# METROPOLITAN GOVERNMENT OF NASHVILLE AND DAVIDSON COUNTY

## STAFF RECOMMENDATION 1705 Woodland Street November 20, 2013

**Application:** Demolition; New construction- infill and outbuilding  
**District:** Lockeland Springs-East End Neighborhood Conservation Zoning Overlay  
**Council District:** 06  
**Map and Parcel Number:** 08310030100  
**Applicant:** Van Pond, Architect  
**Project Lead:** Sean Alexander, sean.alexander@nashville.gov

Proposed Site Plan  
SCALE 1/16" = 1'-0"

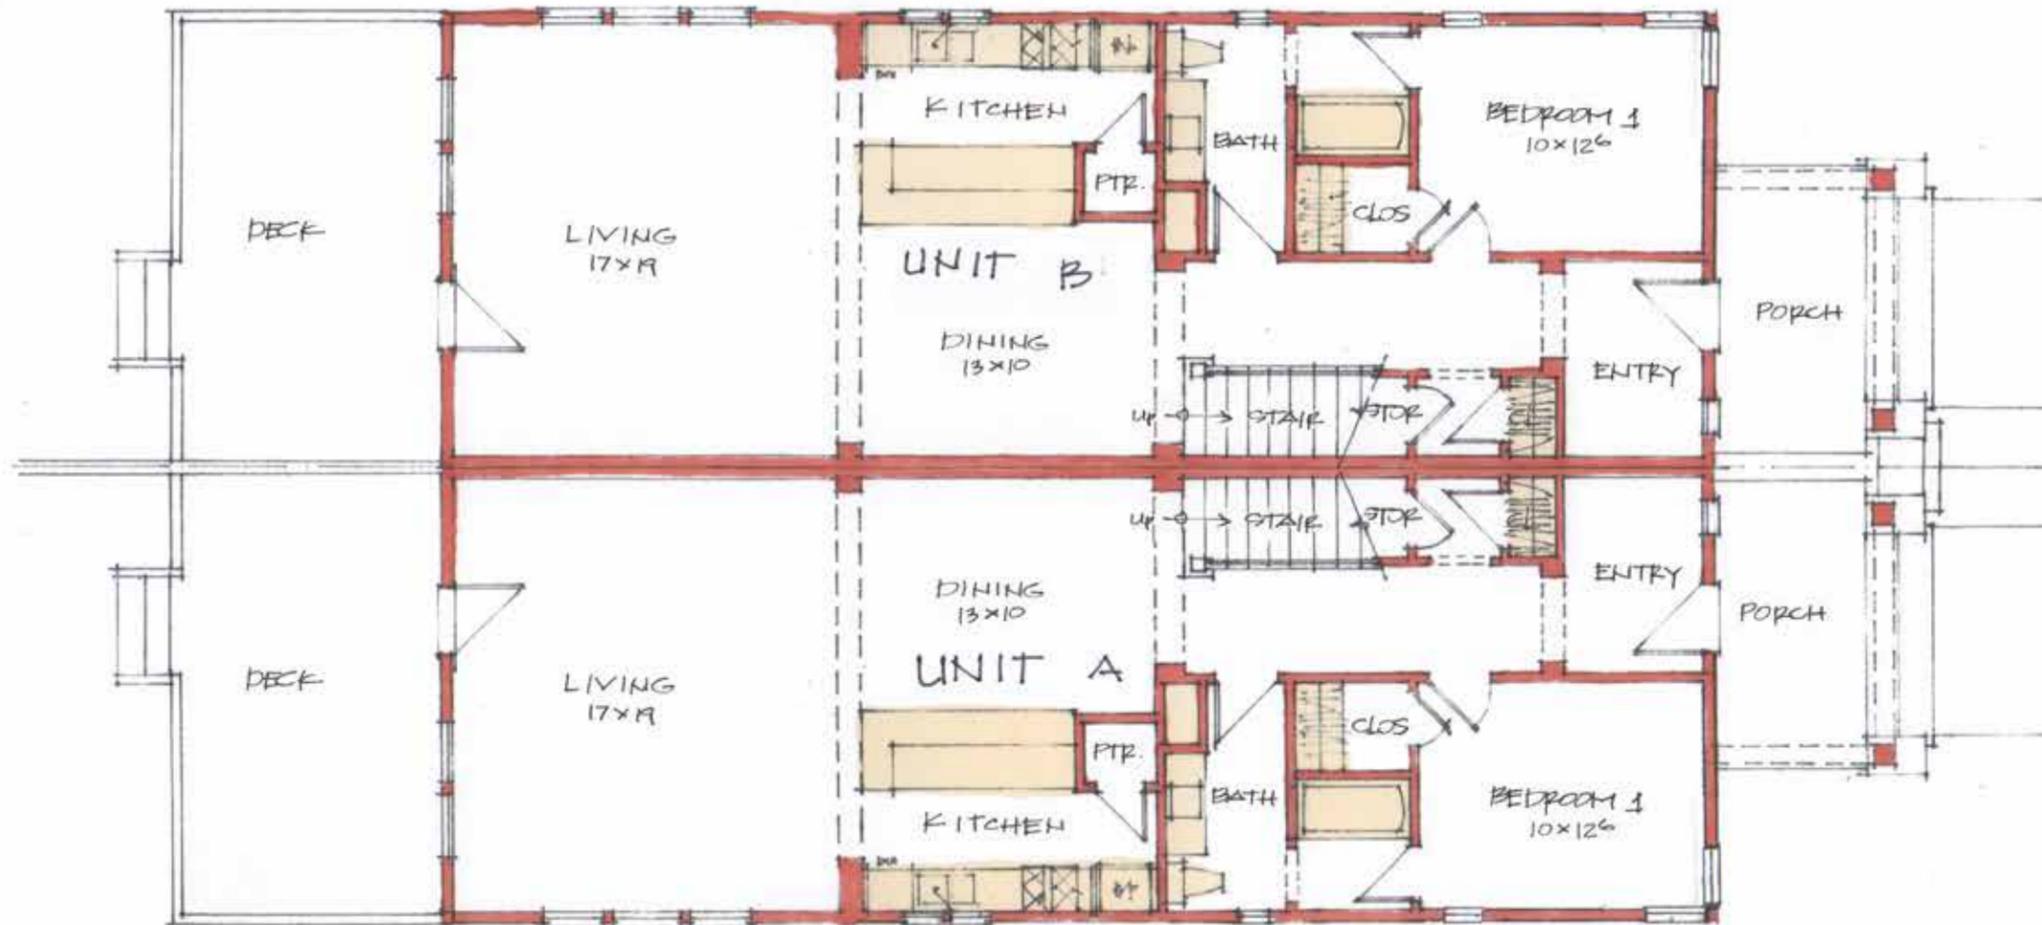
The HVAC and exterior mechanical connections are shown as being on the sides of the structure, roughly ten feet (10') from the front edge of the house. Staff asks that the HVAC be located on the rear façade, or on a side façade beyond the midpoint of the house, which would meet guideline II.B.9.

- The width of the building and the massing of the upperstory be reduced;
- Staff approve the color of the roof and the materials of the windows and doors;
- The HVAC units and utilities be located behind the midpoint of the structure,

**Proposed Upper Floor Plan**  
 SCALE 1/8" = 1'-0"

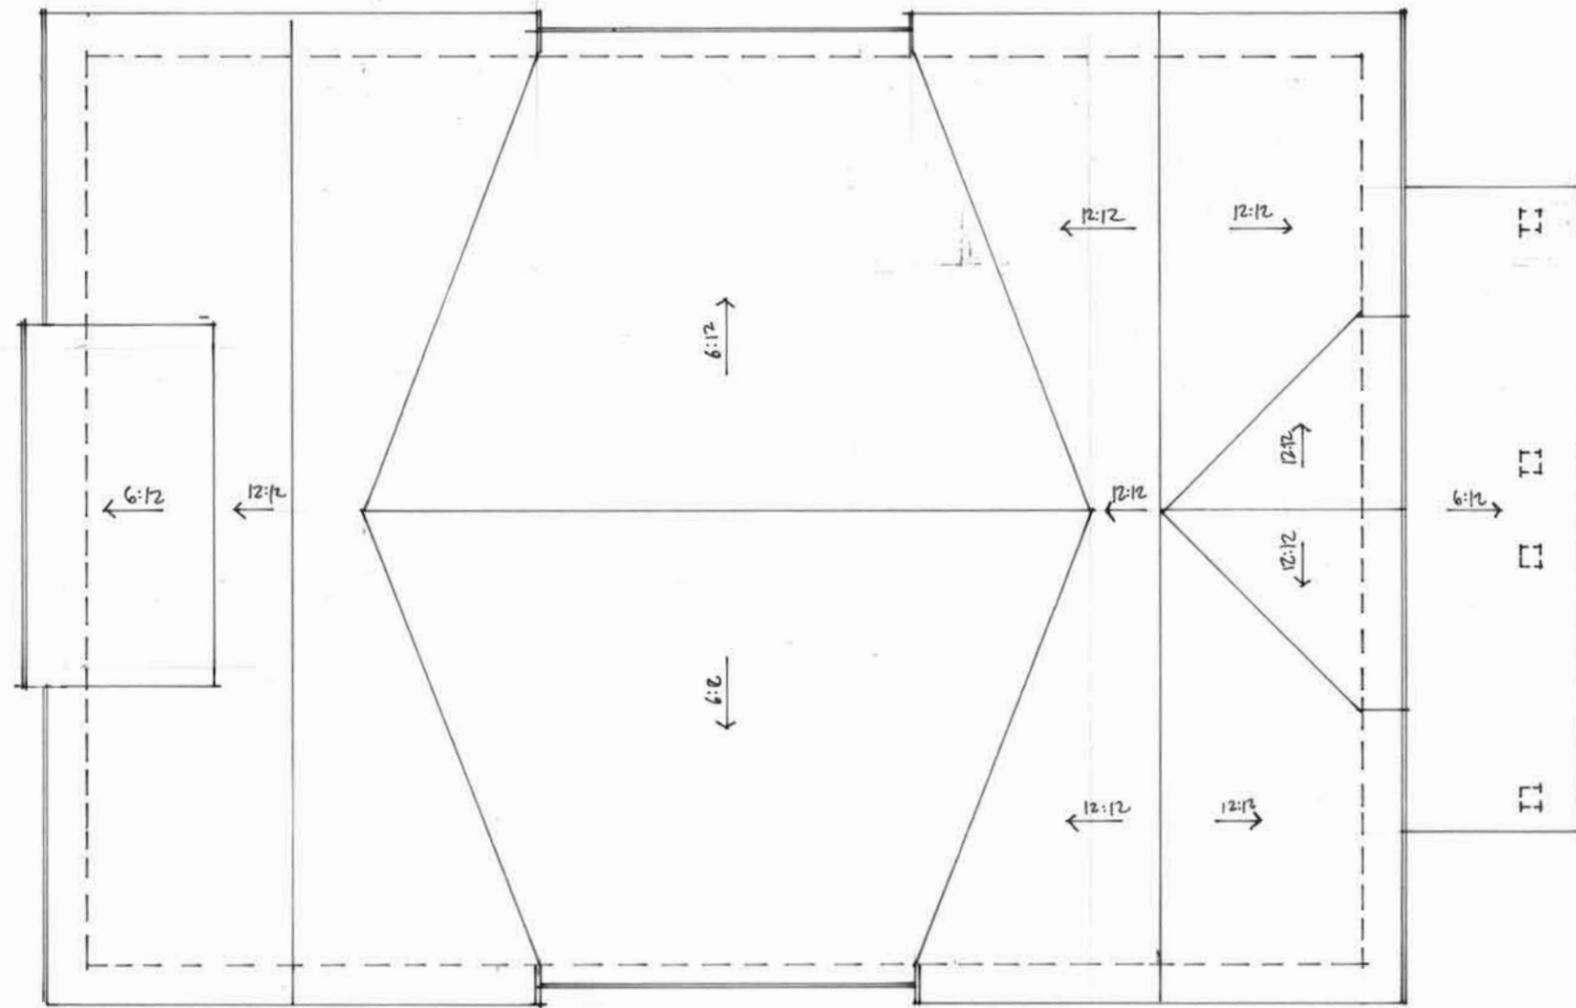
The building will be forty feet (40') wide across the front elevation, with a twenty-six foot (26') wide front porch shared by both units. The primary mass of the building will be fifty-six feet (56') deep, front to back, without any articulation on the side walls. There will be a porch projecting eight feet (8') to the front. Historic houses nearby are generally between twenty-eight feet (28') and thirty-five feet (35') in width, with thirty-two feet (32') being the most common width for both one and two-story houses. Two wider houses in the area, 1715 Forrest Avenue and 1624 Holly Street, are on either a double-lot or have an articulated form (ex. Queen Anne) that helps to reduce the perceived massing.

Because the width of the proposed new building is wider than is typical of historic houses nearby, Staff posits that it would disrupt the rhythm of setbacks and spacing established by uniform lot width and consistent building widths found in the historic context. Staff finds that the proposal would not meet guideline II.B.3.

Furthermore, because the structure would have a symmetrical two-story front elevation, the massing of the upperstory would further disrupt the rhythm of spacing created by the existing Bungalow and Folk Victorian forms which generally have less massing in their upperstories.

Staff finds that the scale of the proposed new two-family dwelling does not meet guidelines II.B.1 and 2. Because the height of the new building is appropriate, reducing the width of the structure and breaking up the massing of the upperstory could make the scale of the proposal more compatible with the historic context.
